City of Portland, Maine - Building or Use Permit Application

Permit No. 02-0029	Issue Date: FEB 18 2002	CBL: 320 A002001
--------------------	-------------------------	------------------

RE: **400 RIVERSIDE AVE, PANTIM CO.**

Project:
RENOVATION UNIT E-3
400 RIVERSIDE STREET
PORTLAND, ME

Plan

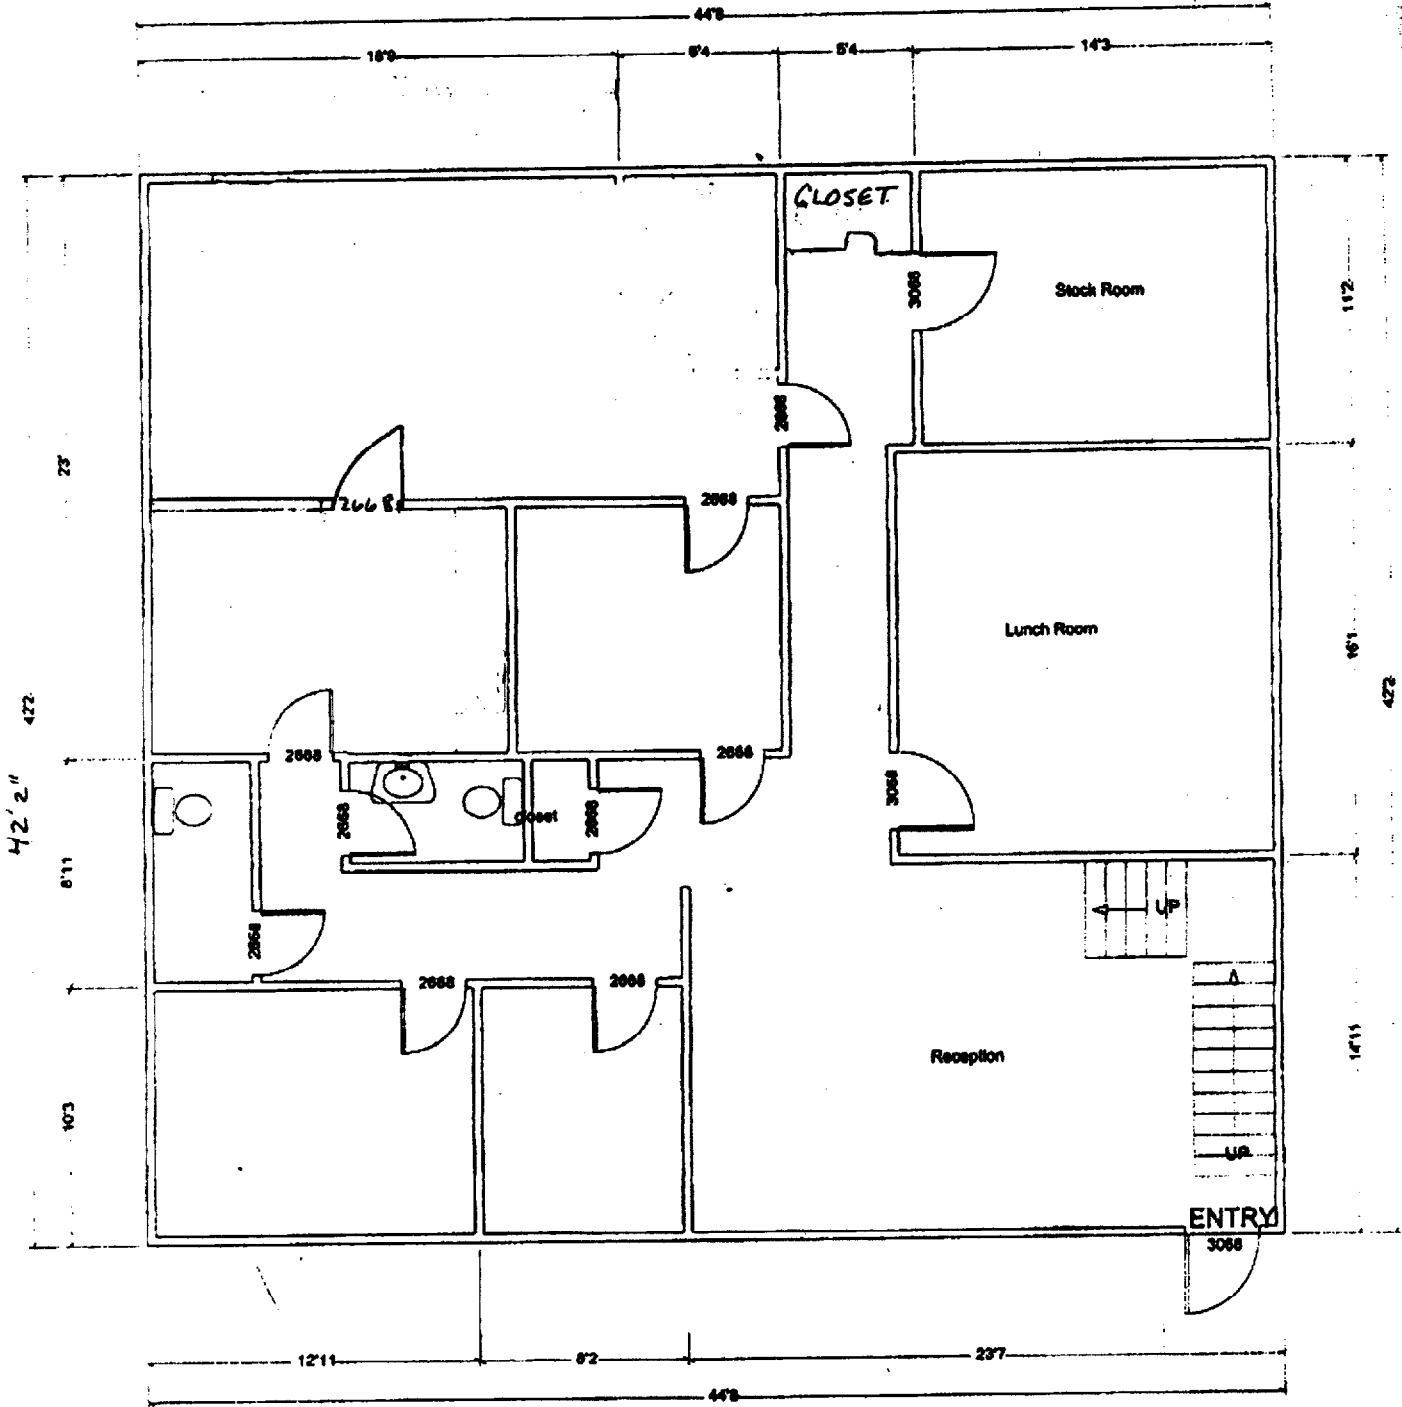
DATE	TIME	CONTACT	NARRATIVE	INITIALS
			Both	
			① Identify Use Curved	Office
			② 2nd Floor Flat Plan	Woods
			Meal On-Site Mon 1/28 9:30	
			MSM & DC	
			③ Header Span of 10' with 8'x8' beam	
1/24/02	2:15		Called Sunrise left message for call back regarding 8'x8' beam 10' span	
	3:40		Spoke with the Sunrise He will contact lumber yard for the 1x4 and have spec sheet faxed over	
1/30			Separation Between S1 & B use require 3HR separation Buckler Advised

Following headers will be used
as recommended by manufacturer:

" 3 1/2 x 11 7/8 Parallel PSL "
